Anita Gardner
Principal Planning Officer,
Directorate of Place

carlton design partnership ltd

CM/64/19/PL and CM/16/20/PL

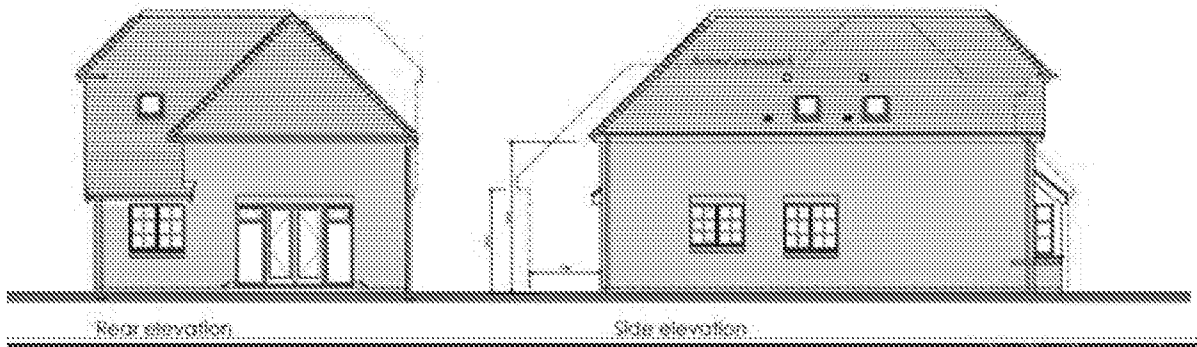
Please see an extract of a representation I have received . Can you provide comment on the differences between the plans and why it seems there is a difference in the approved drawings when they are imposed over the proposed by him?

Below is a photo of the plans of plot 8, CM/64/19/PL and plot 8, CM/16/20/PL. I have traced the outline of CM/64/19/PL on to CM/16/20/PL. Both plans were drawn to the same scale as the widths of the two designs are identical and both were printed out on the same printer. You will notice that my red dotted outline appears significantly different to the one supplied by the applicant – see below. Not only does the roof appear higher but also longer. This leads me to believe that either the original plans have been altered or the architect has made a mistake drawing in the red dotted outline on the new plans.

The length of the house is as shown, however the positioning of the plot is relative to the parking bay in front, consequently we have tried to move new the plot as far north as we can so as to limit the impact at the rear. To locate the plots, the corner of the window bay is the same in both versions (as per the plans I sent you recently) but the posts and overhangs are not the same in both schemes , hence the slight difference in appearance/length.

In respect of the dotted roof/ridge lines it appears the representation is shows a much lower roof line which is in fact the rear of the previous scheme, whereas we have shown the front of the outline of the previous scheme. For clarity, I am attaching an image showing the both the front roof and the rear roof superimposed over the rear elevation.

I would also add the latest drawings are based on a construction/technical drawing to ensure the actual internal dimensions/clearances required are being achieved. I hope that helps.
